SK 0.01

PLAN: RELOCATED TREE
ROANOKE ISLAND FESTIVAL PARK
Wayfinding, Visitor Center & Museum Improvements

SC: 1/4" = 1'-0"
DATE: 18 JAN 2013

1 PLAN: RELOCATED EXISTING FAUX TREE
SCALE: 1/4" = 1'-0"

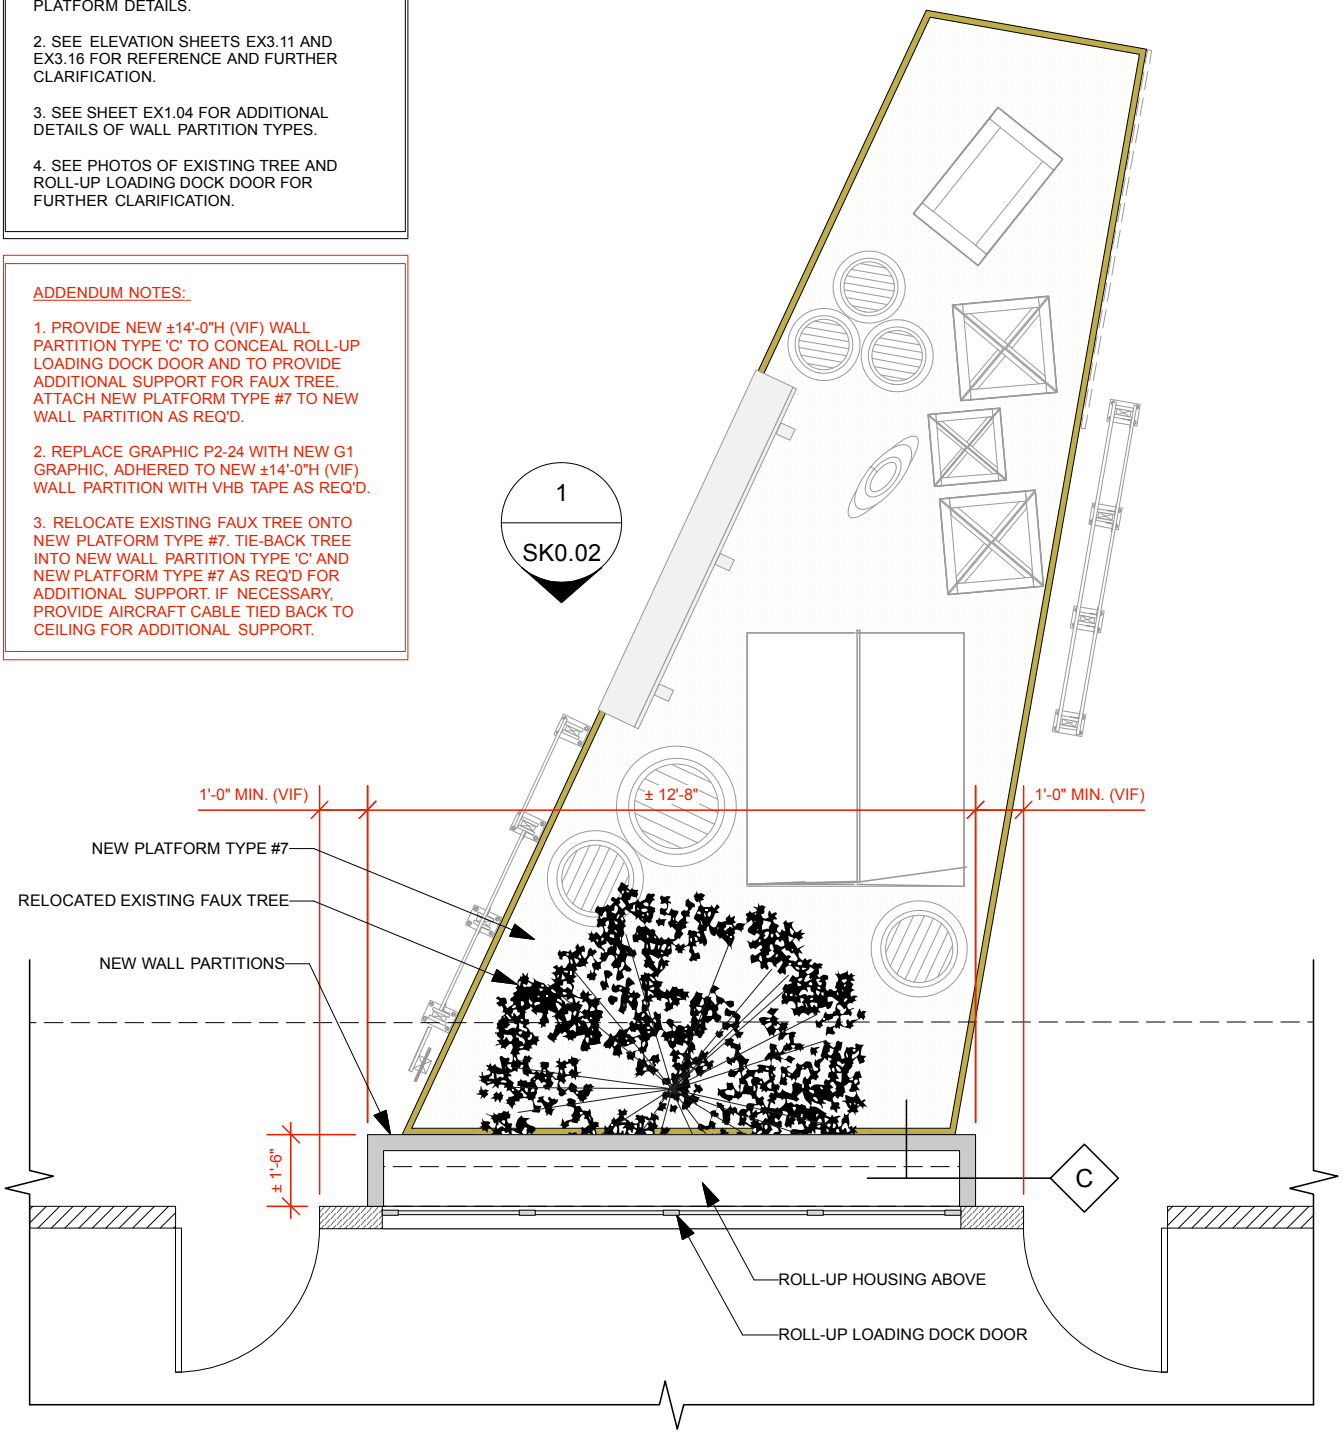
1. PROVIDE NEW ±14'-0"H (VIF) WALL PARTITION TYPE 'C' TO CONCEAL ROLL-UP LOADING DOCK DOOR AND TO PROVIDE ADDITIONAL SUPPORT FOR FAUX TREE. ATTACH NEW PLATFORM TYPE #7 TO NEW WALL PARTITION AS REQ'D.

2. REPLACE GRAPHIC P2-24 WITH NEW G1 GRAPHIC, ADHERED TO NEW ±14'-0"H (VIF) WALL PARTITION WITH VHB TAPE AS REQ'D.

3. RELOCATE EXISTING FAUX TREE ONTO NEW PLATFORM TYPE #7. TIE-BACK TREE INTO NEW WALL PARTITION TYPE 'C' AND NEW PLATFORM TYPE #7 AS REQ'D FOR ADDITIONAL SUPPORT. IF NECESSARY, PROVIDE AIRCRAFT CABLE TIED BACK TO CEILING FOR ADDITIONAL SUPPORT.
